**Moorhead Area Public Schools Improvements  
High School Track Replacement and Artificial Turf Installation  
Moorhead, Minnesota**

**Project No.** 13-043  
**Date:** February 27, 2014

### **ADDENDUM No. 1**

**ADDENDUM NO.1**

**13 4' OR 6' CHAIN LINK FENCE DETAIL (BY 32B)**  
**C6.0 NOT-TO-SCALE**

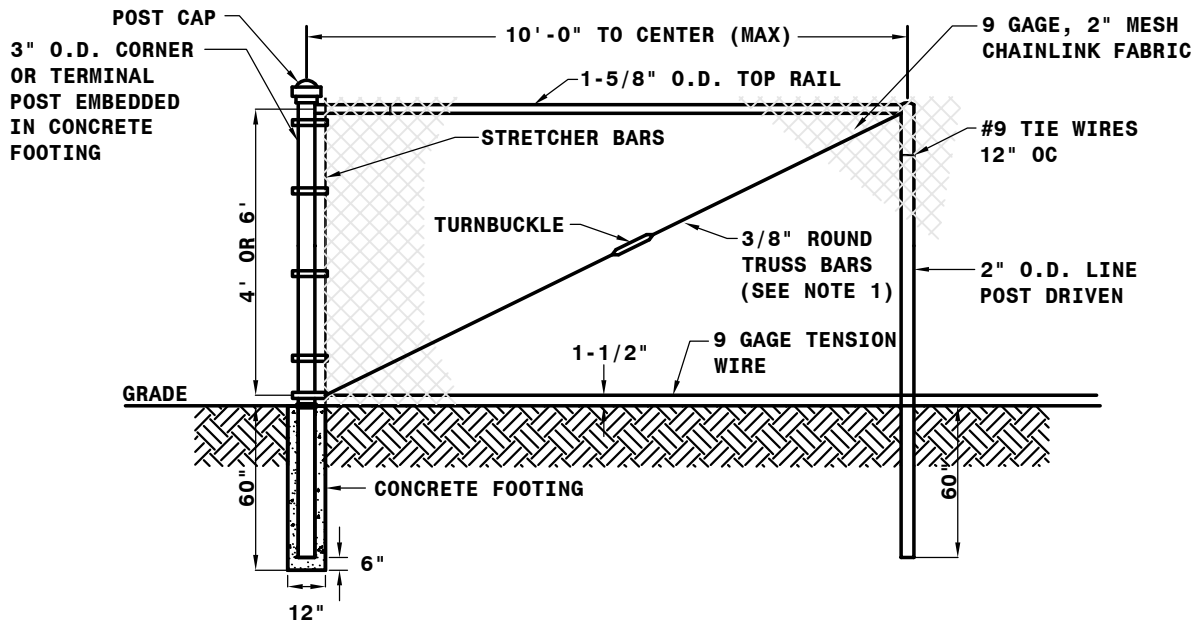
1. See attached sheet R1/C6.0. Detail 13/C6.0 has been revised to show only 9 gauge tension wire along bottom of fence and no bottom rail.

1. TRUSS BARS ARE REQUIRED FOR EACH GATE SECTION AND THE FIRST SPAN ON EACH SIDE OF A CORNER POST ONLY.
